Staff Report
City of Richmond, Virginia

Commission of Architectural Review

| 11. COA-107846-2022 | Conceptual Review | Meeting Date: 3/22/2022 |
| Project Description | Construct a new 10-unit, 3-story, multi-family building on a vacant lot. | |

Figure 4. Demonstration of irregular form of the existing corner commercial, and irregular form of new construction in response.

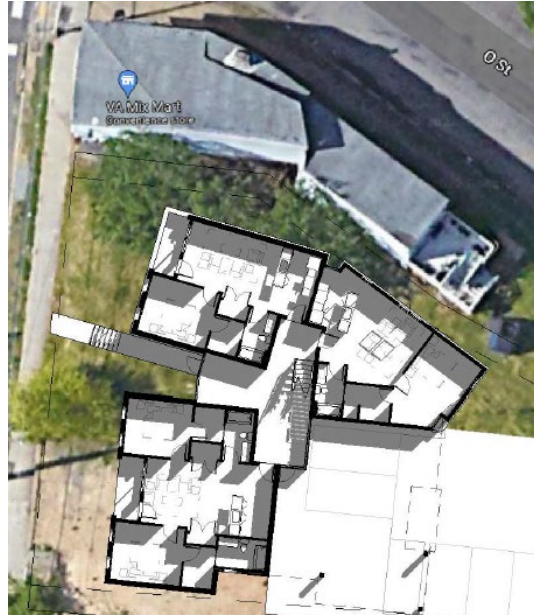
| | | <p><u>transparent material or match the railing of the balcony above.</u> This change in material would also break up the expanse of brick used at the base of the building.</p> <p>The overall form of the two-story mass is irregular, most likely in response to the irregular form of the corner commercial store to the north (see figure 4).</p> <p>For the three-story section:</p> <p>The three-story section of the building be three bays wide on the front façade, the center bay being recessed to create covered balconies. Staff finds that this form is in-keeping with the district.</p> <p>The rear will feature a cantilevered mass over a parking area.</p> |

| Staff Recommendations | <ul style="list-style-type: none"> The two-story section of the building be oriented parallel with Mosby Street to reinforce the street wall of the existing buildings on the block. The masonry wall surrounding the patio be replaced with a more transparent material or match the railing of the balcony above. | |
